FAQ Number 10-0059 FAQ Revision 56

FAQ Title NFPA 805 Monitoring

Plant: Harris Nuclear Plant Date: _____
Contact: Joelle DeJoseph/Dave Phone: 919-546-6247/479-857-1975/402-825-5467
Miskiewicz/Jessica
Walker/Tom Shudak
Email: joelle.dejoseph@pgnmail.com
jwalker@jensenhughes.com/tgshuda@nppd.com

Figure E-2 – NFPA 805 Monitoring – Scoping and Screening

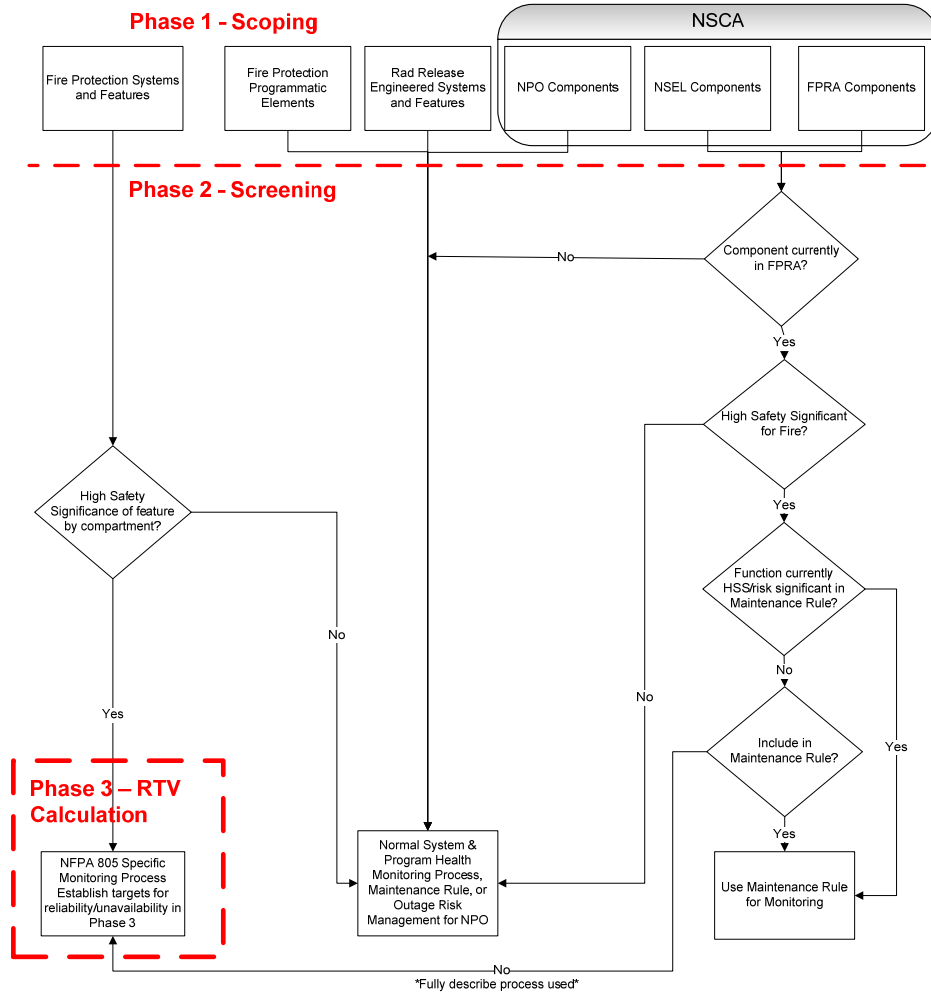
Commented [TS1]: SW - Should this have an item that says in MR as HSS, then follow Maintenance Rule?
